Case File / Name: SUB-0057-2023 DSLC - BANKS 20 City of Raleigh
Development Services Department
One Exchange Plaza
Raleigh, NC 27602
(919) 996-2492
currentplanning@raleighnc.gov
www.raleighnc.gov

REQUEST: This is a proposed subdivision to create a total of 578 lots and street right-of-way.

approval being met, conforms to the Unified Development Ordinance. This approval is based on a preliminary plan dated April 17, 2025 by Mungo

TT24 TUFF TRACK ENGINEERED PERMEABLE PAVER **GRASS SURFACE**

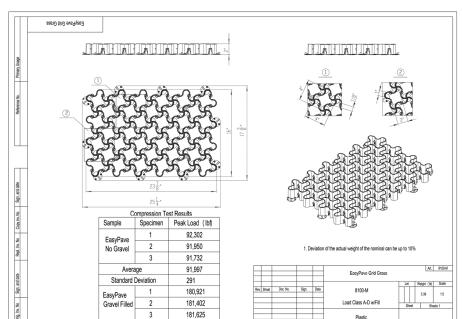
- 16. From the 4th to 5th reviews a new detail was provided as part of a RFD Alternative Material or Design Request that showed grass pave for potential fire access in the medians. Transportation has significant concerns with long term maintenance. From a maintenance perspective, we would be more amenable to a monolithic mountable island or similar design. This will be further addressed prior to SPR issuance and must be agreed to prior to SPR approval. Alternatives may require encroachment.

Date Received:12/11/2024
Evaluation of Proposal by: RFD Office of the Fire Marshal
Suitability: Okay
Strength:Okay
Effectiveness: Okay
Fire Resistance:
Durability:Okay
Safety:
Sanitation:
Recommended Action: APPROVE XXX DENY By: KT Bailey - Assistant Fire Marshall
Conditions:Curb detail - I will approve as shown to expedite the review - Change the curbing

detail to show a 1" reveal instead of the 1-3/4" as shown.

POD B - RX BASE DISTRICT POD G - RX BASE DISTRICT DISTRICT DENSITY PLAN C0.06

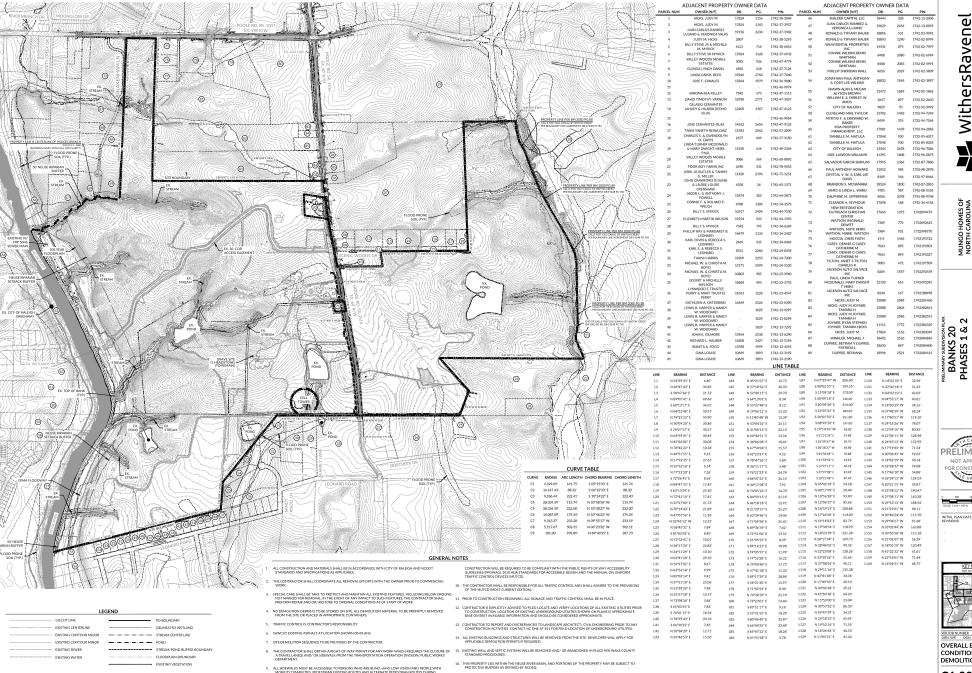
- 4. Update the cover sheet, sheet C0.06, and all subsequent sheets to uniformly specify the number and types of all lots (including lots to be owned by the property owners' association) being created in phases 1 and 2. Clearly label on all plan sheets the common area and open space lots to be owned by the property owners' association.
